of resource consent
application
(SL2300006) for a
commercial and rural
services development
at **7 Millbrook Road,
Waipu**

**EVIDENCE OF TODD JAMES LANGWELL ON BEHALF OF VACO
INVESTMENTS (WAIPU PROJECT) LIMITED IN SUPPORT OF ITS
APPLICATION FOR RESOURCE CONSENT**

TRANSPORT

Project Title: Waipu Bypass Service Centre
 Sheet Title: SH1 Northbound Criterion 2 Sight Distance

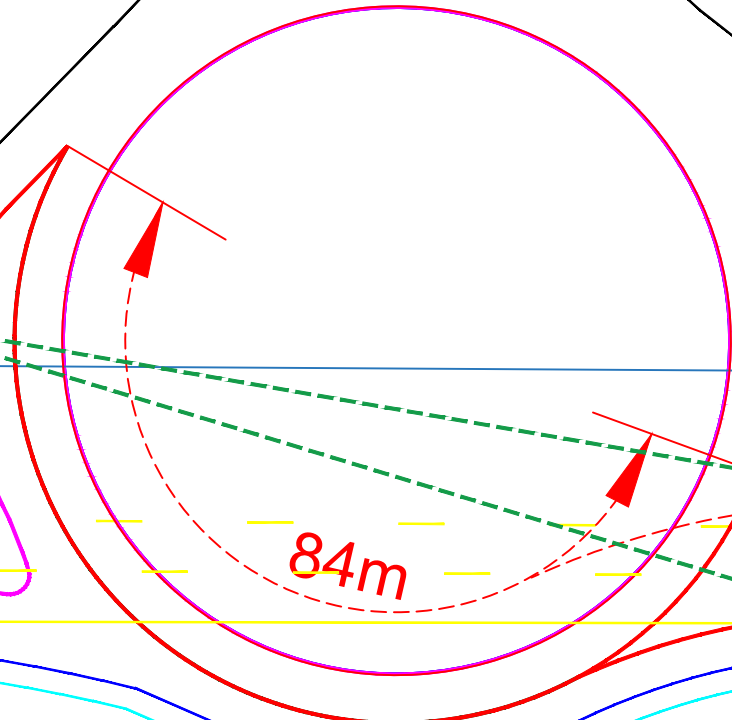
- Drawing DDK 21803 - (14)
 - Shows an 84m sight distance for the opposing approach. This is not considered to be required, as this approach is not *immediately* to the right. The audit team considers that a driver approaching the roundabout should not be focused on this opposing approach before making a decision.

Probability Rating:		Severity Outcome Rating:
Crashes are likely to be	Unlikely	Death or serious injury is Serious
<p>Design Team Response: <i>We agree that with a lower speed for the circulating lane, the criterion 2 sightline can be less onerous, and therefore the central area could be planted and/or landscaped. Such landscaping would mean that drivers can be focussed on the roadway immediately to the right and the circulating lane, rather than across the roundabout at other vehicles. We understand that both American and NZ research papers on roundabout sight distance indicate that providing more than the minimum required intersection sight distance can lead to higher speeds that reduce intersection safety. Landscaping on the central island based on a reduced criterion 2 sightline can be further developed in discussion with NZTA for the detailed design.</i></p>		
Safety Engineer:	Click here to enter text.

Project Title: Waipu Bypass Service Centre
 Sheet Title: SH1 Southbound Criterion 2 Sight Distance

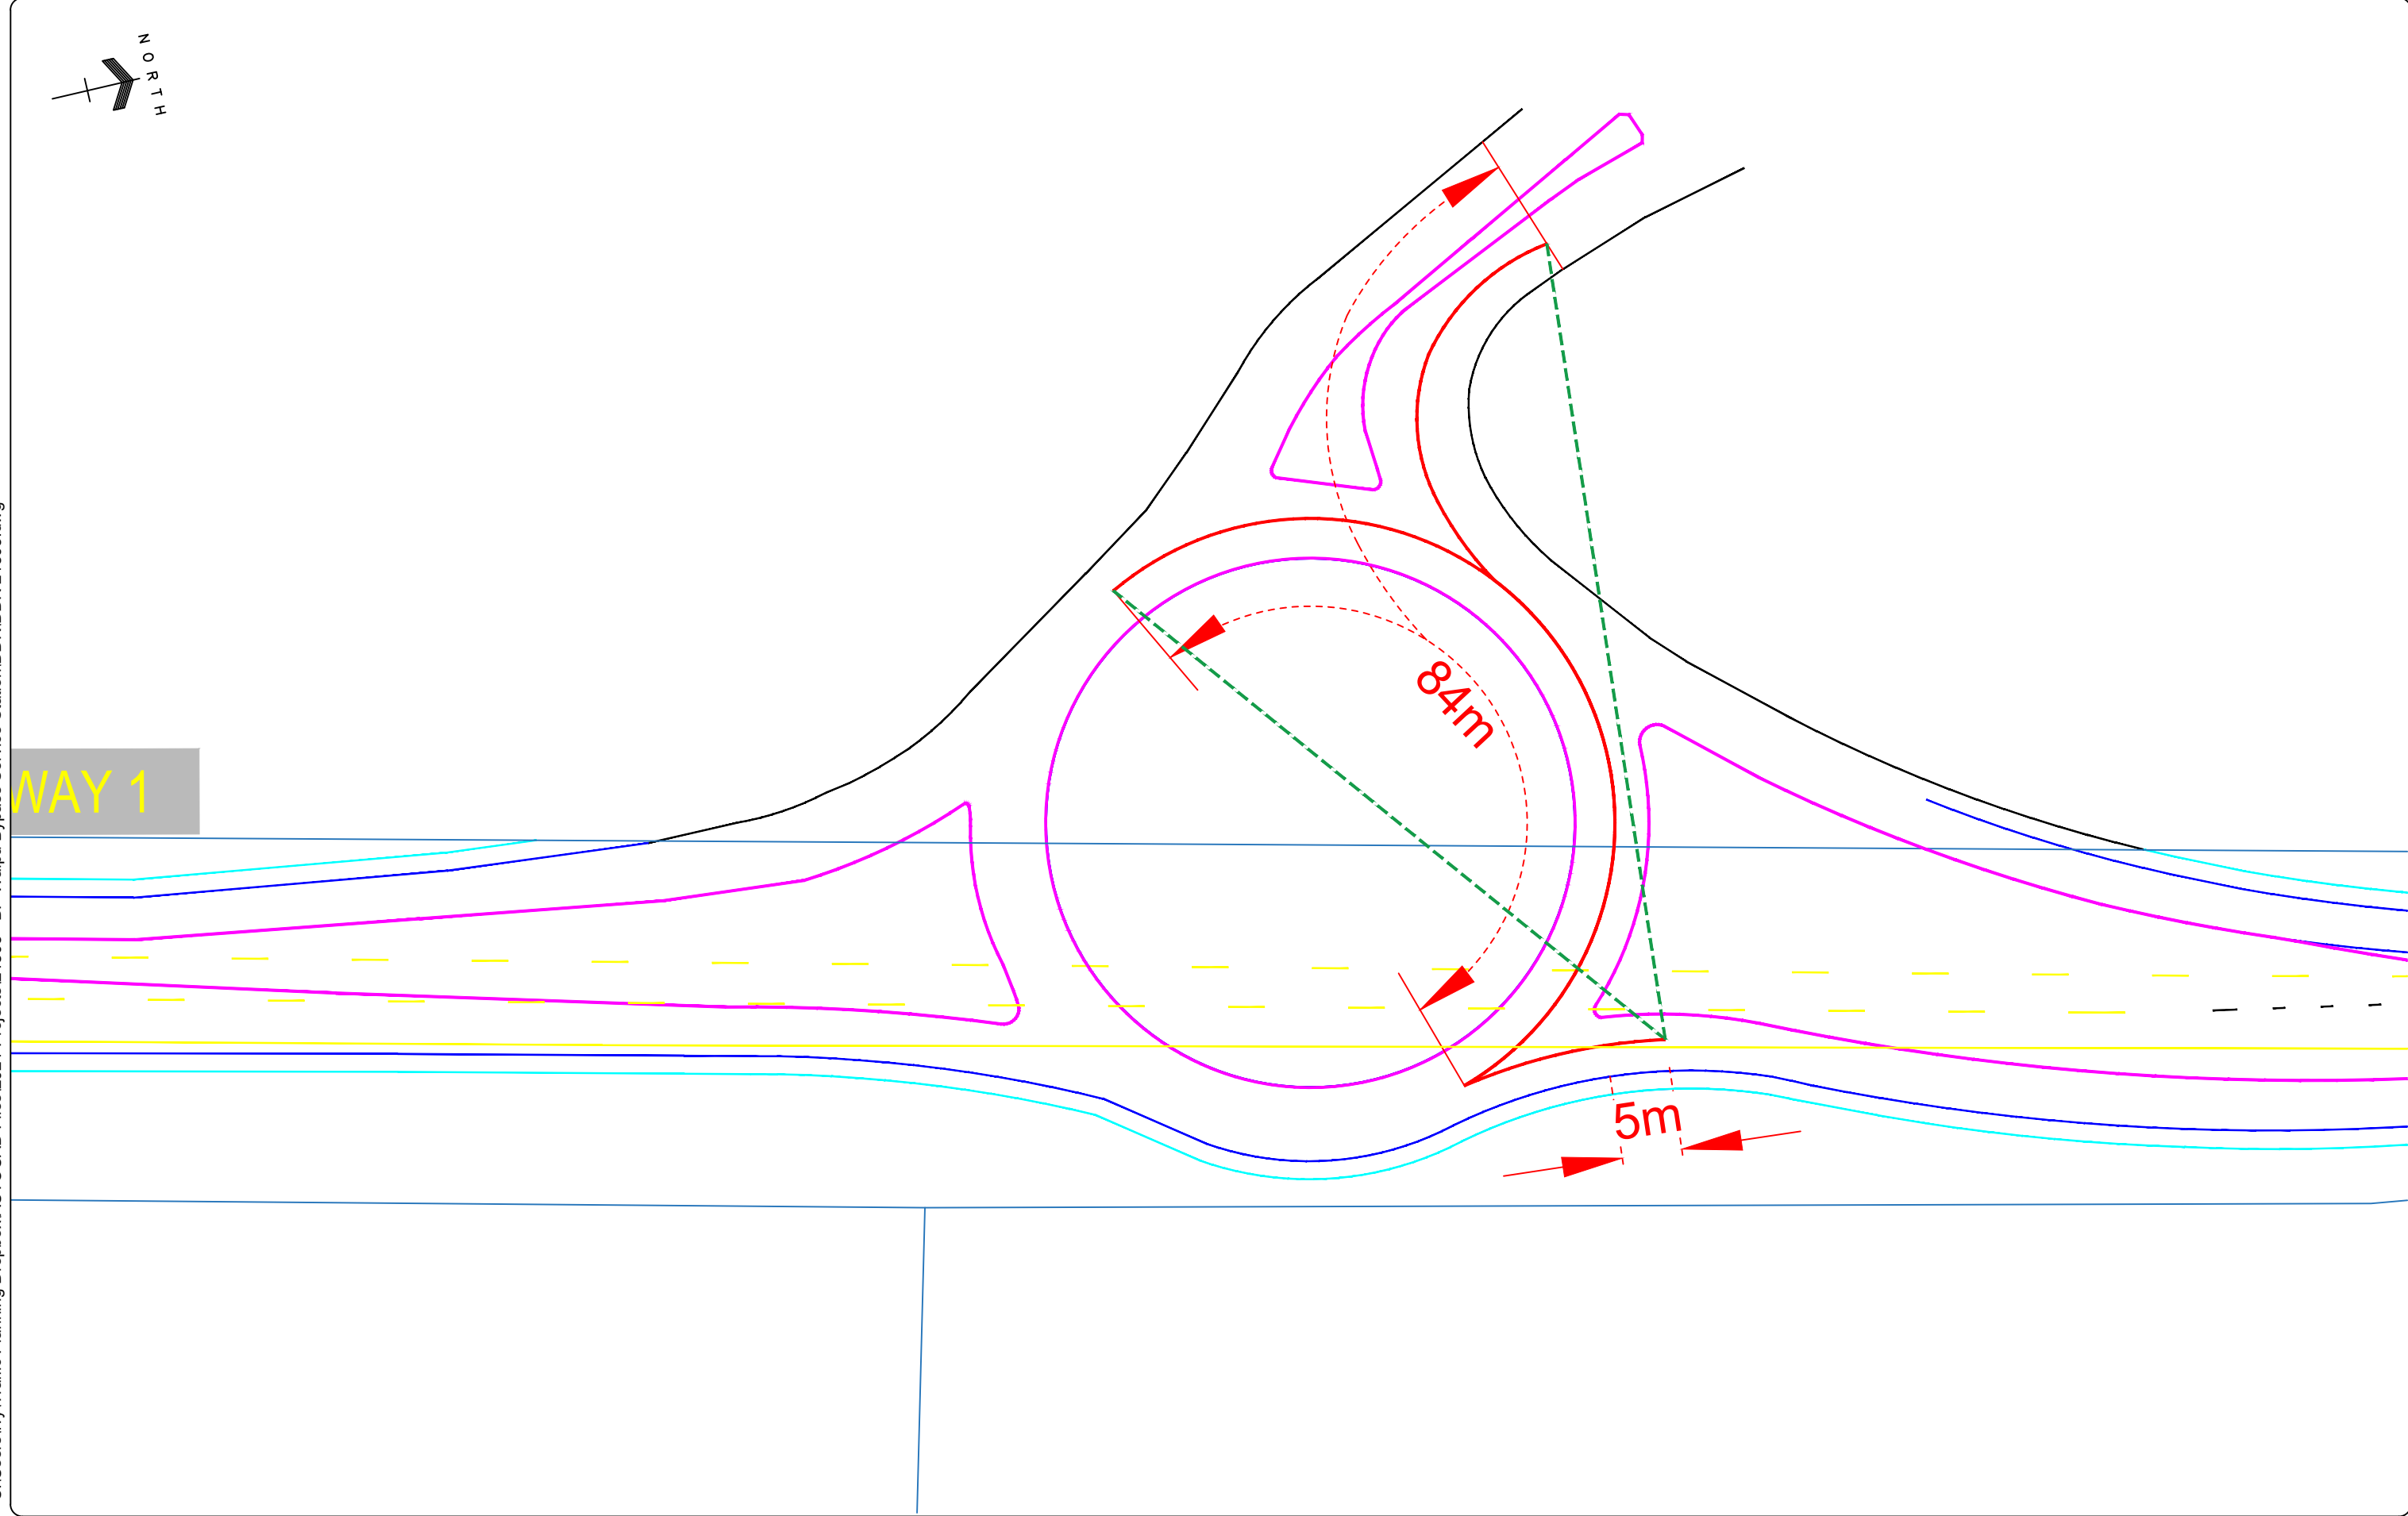
- Drawing DDK 21803 - (15)
 - Shows an 84m sight distance for the approach immediately to the right. This is considered appropriate.
 - Shows an 84m sight distance to a circulating vehicle. The audit team suggests this sight distance should be calculated based on the 85th percentile circulating speed, which will likely be less than 60km/h.

Project Title: Waipu Bypass Service Centre
 Sheet Title: Service Centre Exit Criterion 2 Sight Distance

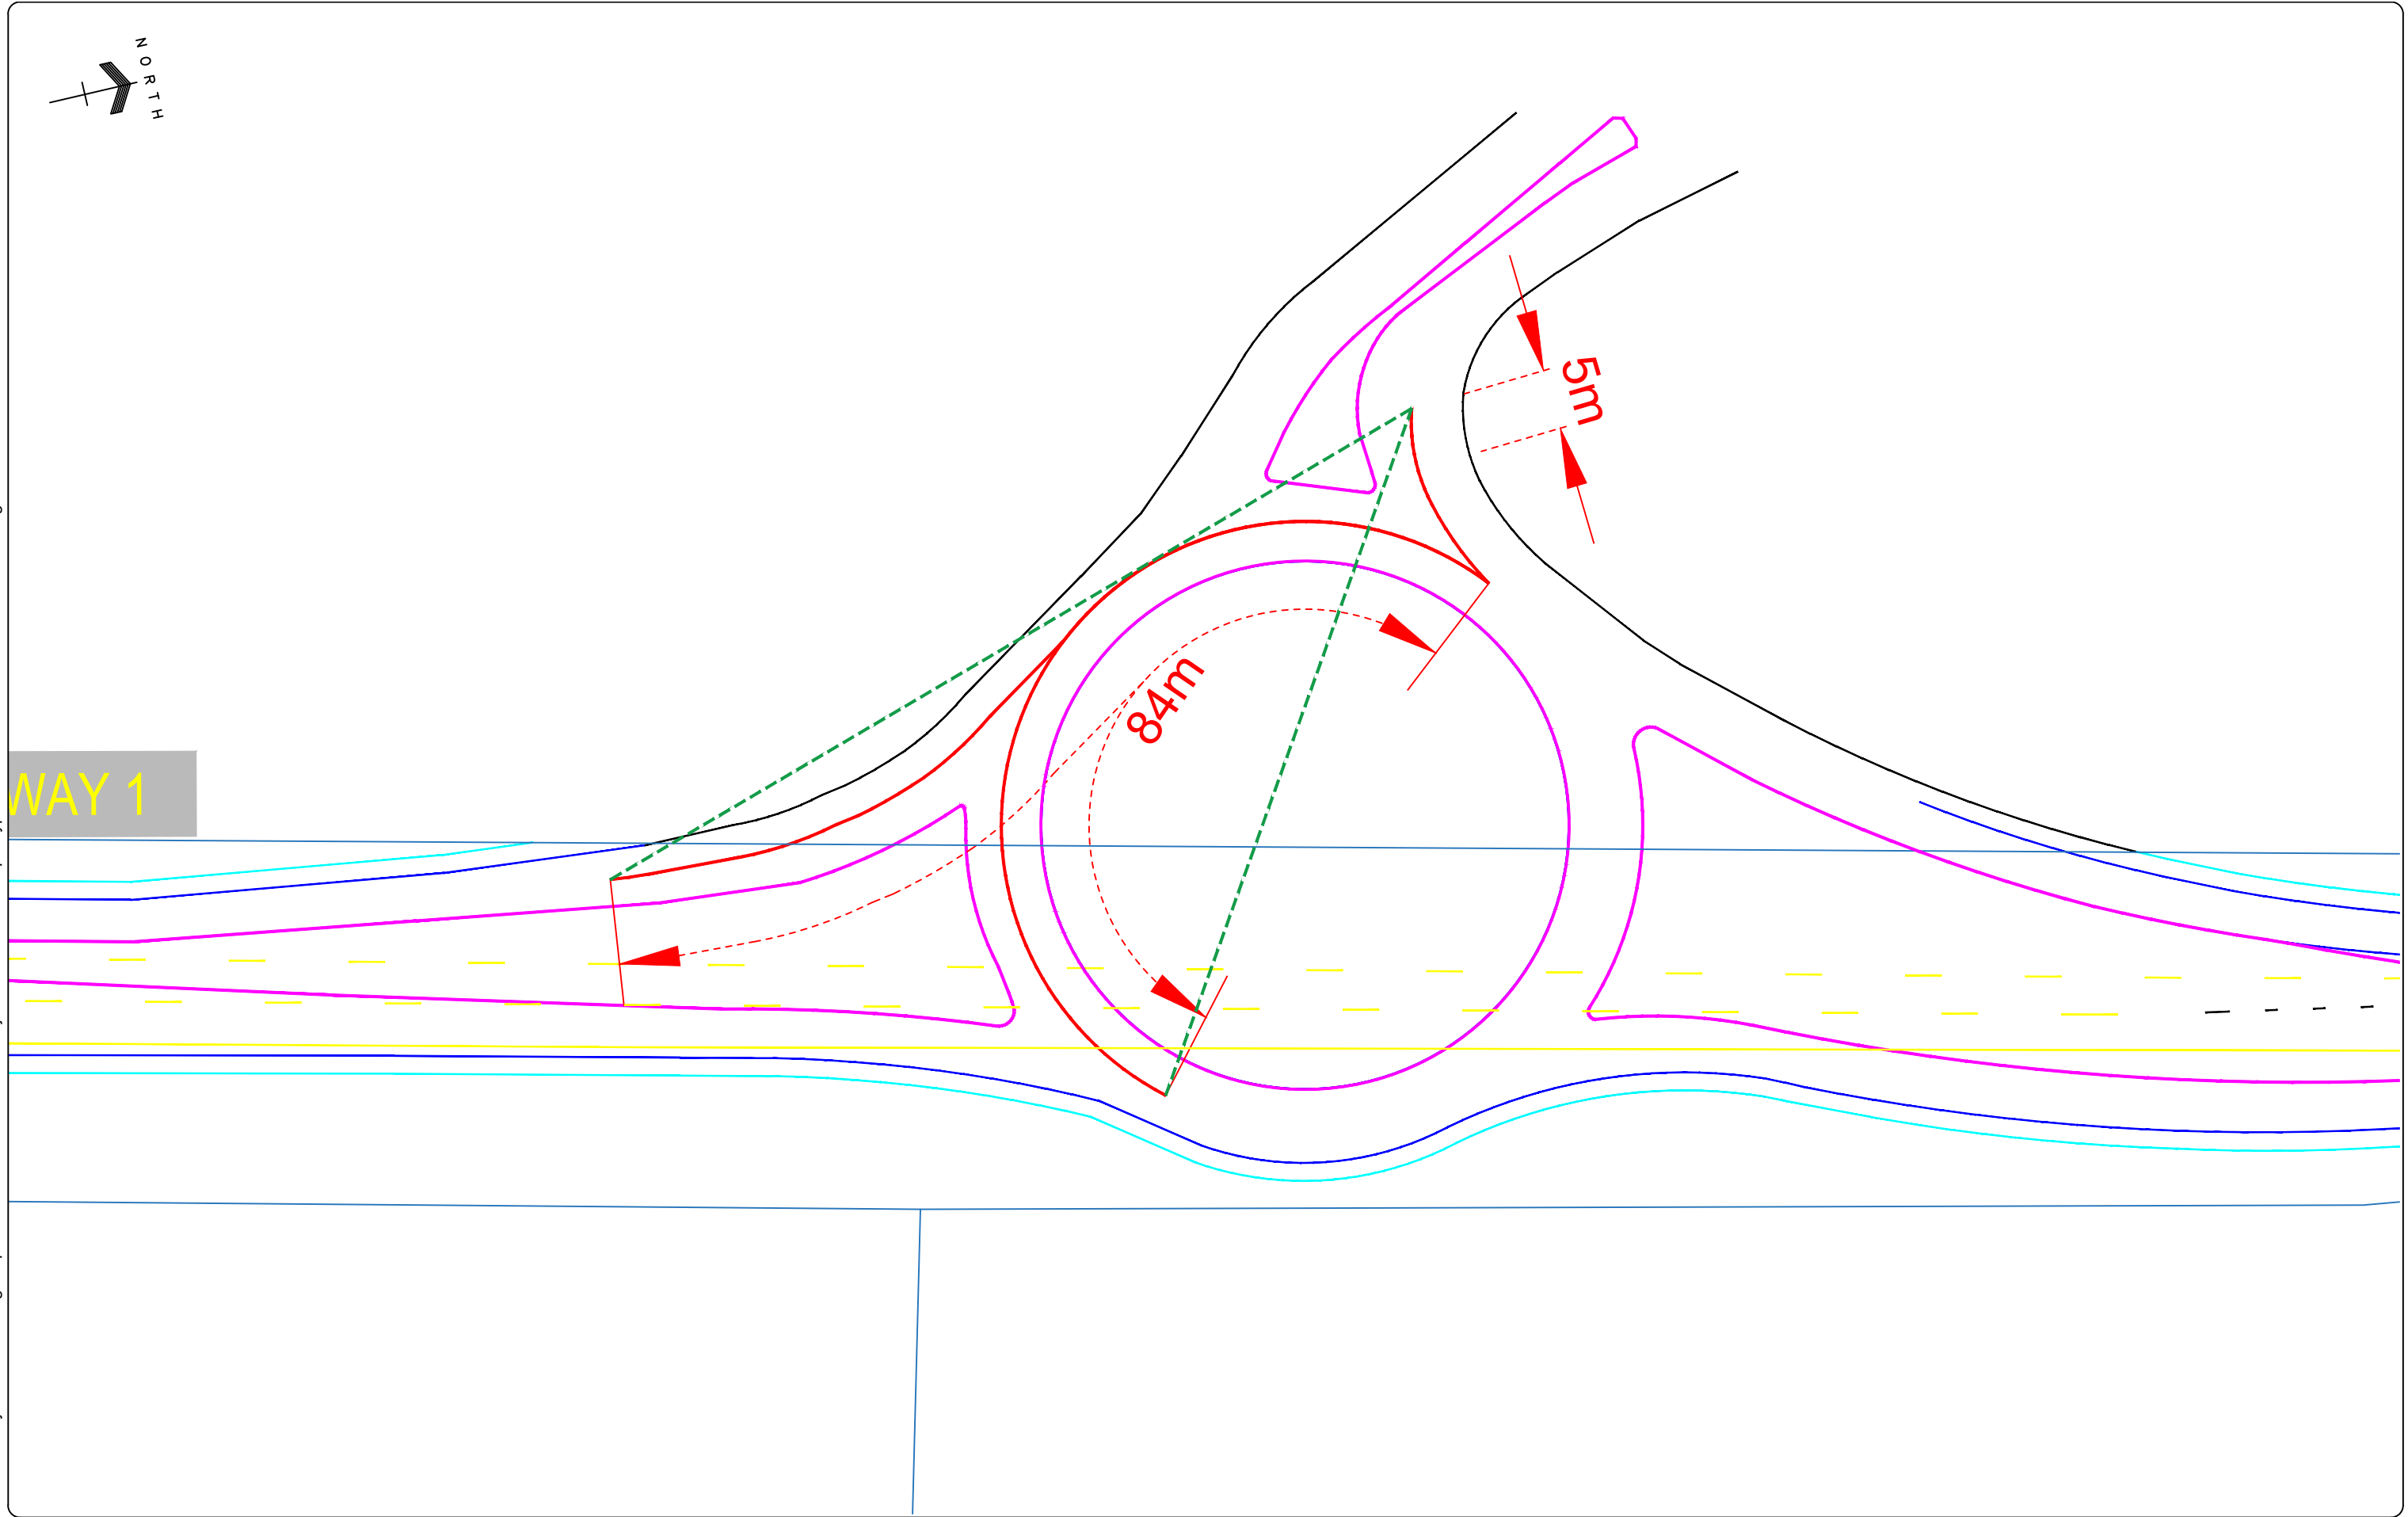
- Drawing DDK 21803 - (16)
 - Shows an 84m sight distance for the approach immediately to the right. This is considered appropriate.
 - Shows an 84m sight distance to a circulating vehicle. The audit team suggests this sight distance should be calculated based on the 85th percentile circulating speed, which will be less than 60km/h.

Following the reassessment as described above, the designer should ensure that the Criterion 2 visibility triangles are not obstructed by signage, planting, or the vertical geometry of the central island. Any shortfalls in visibility could lead to conflicts.

The designer should reassess the Criterion 2 visibility as described above. The designer should ensure that this visibility is not obstructed by signage, planting, or the vertical geometry of the central island.

Figure 5 Southern Shared Driveway Location:

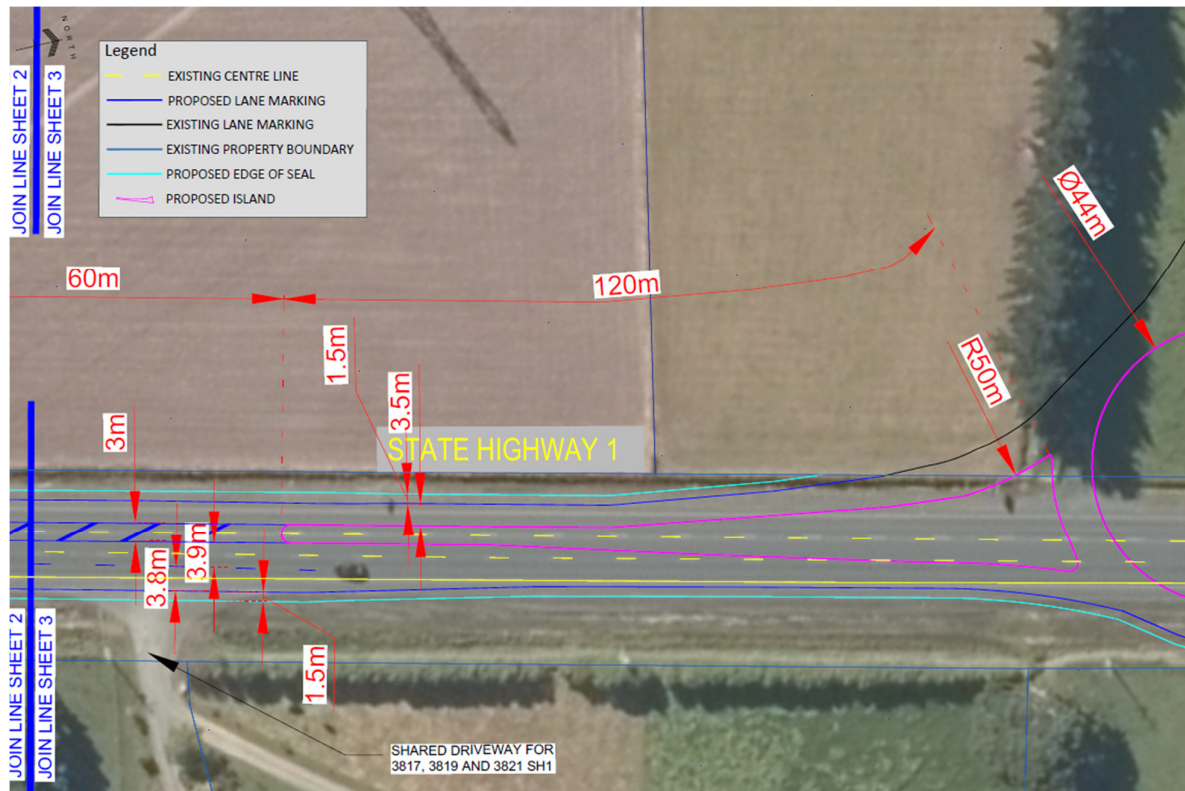
A right turning vehicle from the shared driveway onto SH1 also has potential to conflict with the splitter island, particularly at night. The splitter island should be appropriately signed to ensure vehicles are aware of its presence.

The audit team recommends investigating whether the overtaking lane can commence further south of the shared driveway. It is noted that the proposed passing lane is already below the recommended width, and therefore this also needs to be considered as part of the shared driveway design.

Design Team Response: Agree with audit recommendations. Beginning the passing lane a further 50m south would still leave 830m of passing lane, which is still well in excess of the 650m desirable length of passing lane for a 80km/h operating speed.

Figure 6 Northern Shared Driveway Location

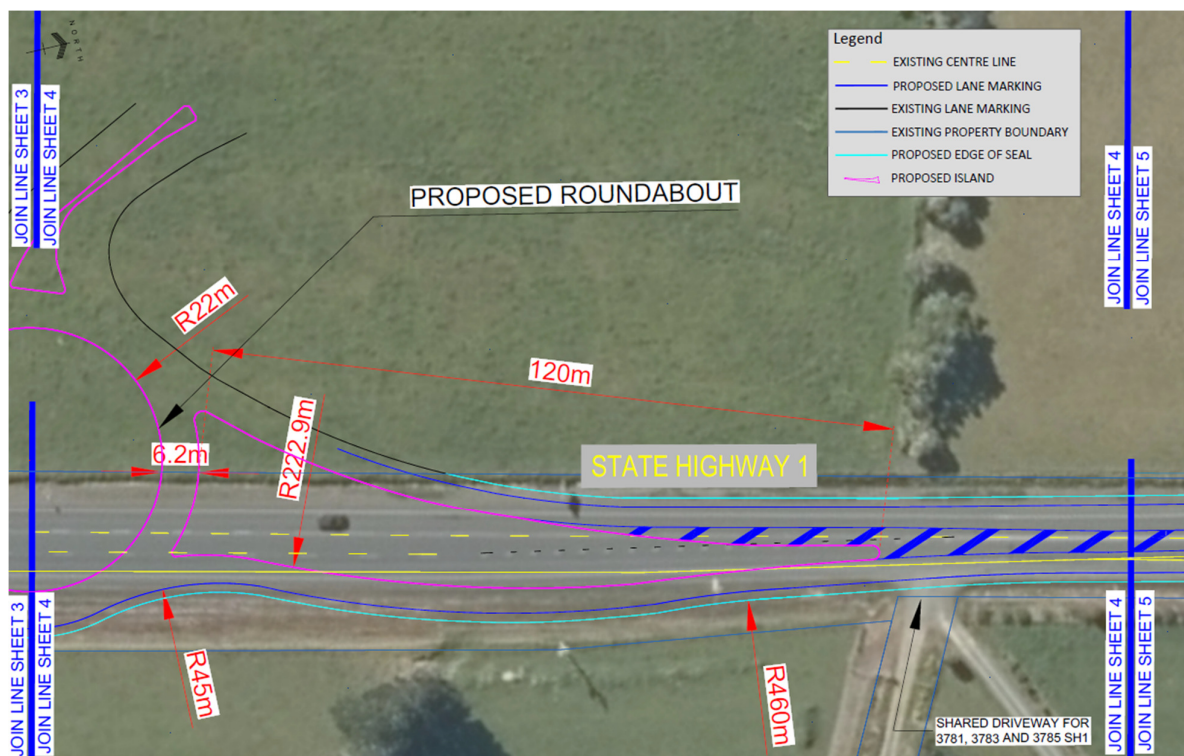
The audit team recommend vehicle tacking of this right turn into the shared driveway is shown, to understand how the vehicle will merge into the right turn area, how a second vehicle will pass, and on what angle the right turning vehicle will be on before turning into the driveway. The audit team is again concerned that northbound vehicle may be shielded from view by a vehicle merging into the right turn area. An exiting vehicle from the shared driveway may not see the northbound vehicle, which could lead to a conflict.

The audit team also recommends visibility of right turning out vehicles to northbound vehicles is considered, when signage is being installed on the splitter islands. These signs need to be located so a full view of northbound traffic is available.

- The designer should show vehicle tracking into the northern shared driveway.
- The designer should ensure visibility to northbound vehicles is maintained for right turning vehicles out of the northern shared driveway.

Design Team Response: Agree – this can be incorporated in the detailed design.
